Product Change Notification

Date Issued :	June 24, 2022	PCN Number :	512149
Reason for Change :	Change to Product		
Description of Change :	This notification is to inform you about changes that are being made to the part(s) as identified in the list. This change will affect the Fit, Form, Function, or appearance of the parts. Or it may result in a change to the specification or raw material.		
Reason for Short Notice :	Custom Products		
Assessment of Change :	First Article Inspection		
Planned Implementation Date :	August 04, 2022		
Sample Availability Date:	July 19, 2022		
Internal Molex Qualification Date :	June 30, 2022		
Last date to request Samples by Customer :	August 01, 2022		
Traceability Code Markings / Date :	Product made after planned implementation date can contain the change

Before Picture

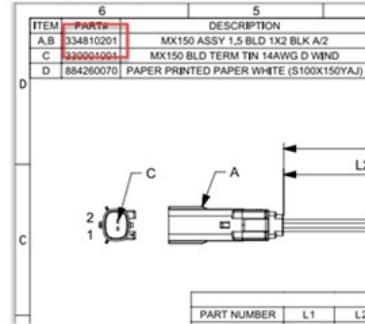
Before – OTS MX 150-see table

- Below mentioned PN drawing was Rev A & connector PN was 334810201 which is getting Obsoleted.

After Picture

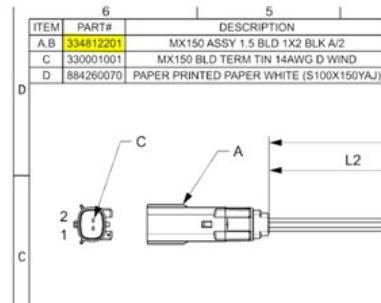
After – OTS MX

- Below mentioned PN have been updated to Rev B & connector PN is changed to 334812201.

- Molex drawing has been updated as per PM mail.
- Product Impact : Impact to fit, form & function of the product.
- Part Impact :
